U.S. Department of the Interior  
BUREAU OF LAND MANAGEMENT

| <b>Well Name:</b> DOME NAVAJO 12-26-13 COM | <b>Well Location:</b> T26N / R13W / SEC 12 / SESE / | <b>County or Parish/State:</b> SAN JUAN / NM  |

**Type of Action:** Plug and Abandonment

**BLM FLUID MINERALS  
P&A Geologic Report**

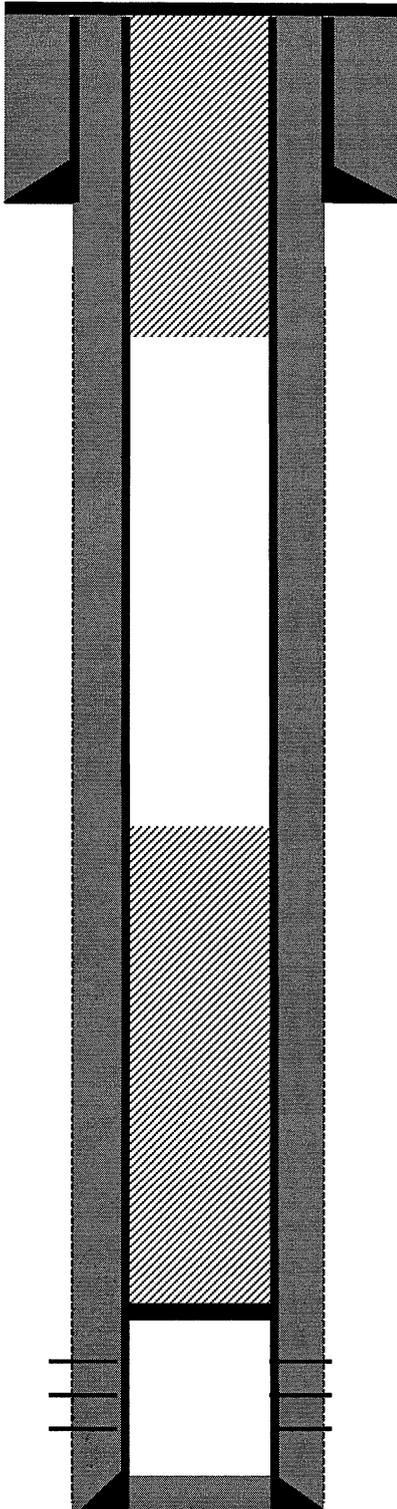
- The plugs proposed in the P&A procedure will adequately protect any freshwater sands in this well bore.
- Fruitland coal perfs 1022' – 1190'.
